## Product Change Notification / ASER-30YJUP974

CCB 3344.004 Final Notice: Qualification of MPHL as an additional final test site for selected AT86RF232-ZX and AT86RF232-ZXR catalog part numbers available in 32L VQFN (5x5x0.9mm) package.

**CCB 3344.004**  
**Pre and Post Change Summary**  
**PCN #: ASER-30YJUP974**

# Tape and Reel - Carrier Tape

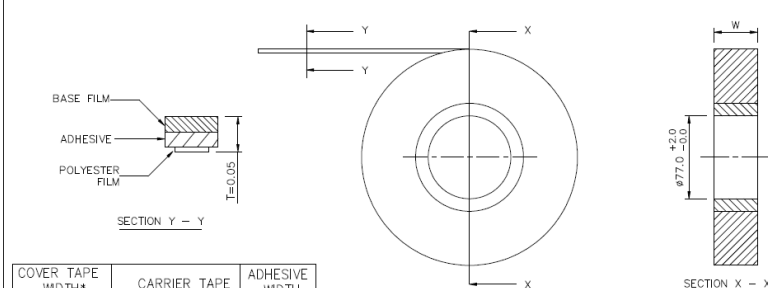
Supplier Mfg. part no.	ML0505-A	QFN0500X0500E
Width (mm)	12	12
Pitch (mm)	8	8
A0 (mm)	5.25	5.30
B0 (mm)	5.25	5.30
K0 (mm)	1.1	1.1

# Tape and Reel - Cover Tape

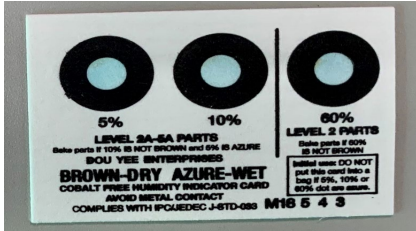
<table border="1"> <thead> <tr> <th>Cover Tape Width</th> <th>Color</th> </tr> </thead> <tbody> <tr> <td>9.2 mm</td> <td>Black</td> </tr> </tbody> </table>		Cover Tape Width	Color	9.2 mm	Black	<table border="1"> <thead> <tr> <th>Cover Tape Width</th> <th>Color</th> </tr> </thead> <tbody> <tr> <td>9.3 mm</td> <td>Black</td> </tr> </tbody> </table>		Cover Tape Width	Color	9.3 mm	Black
Cover Tape Width	Color										
9.2 mm	Black										
Cover Tape Width	Color										
9.3 mm	Black
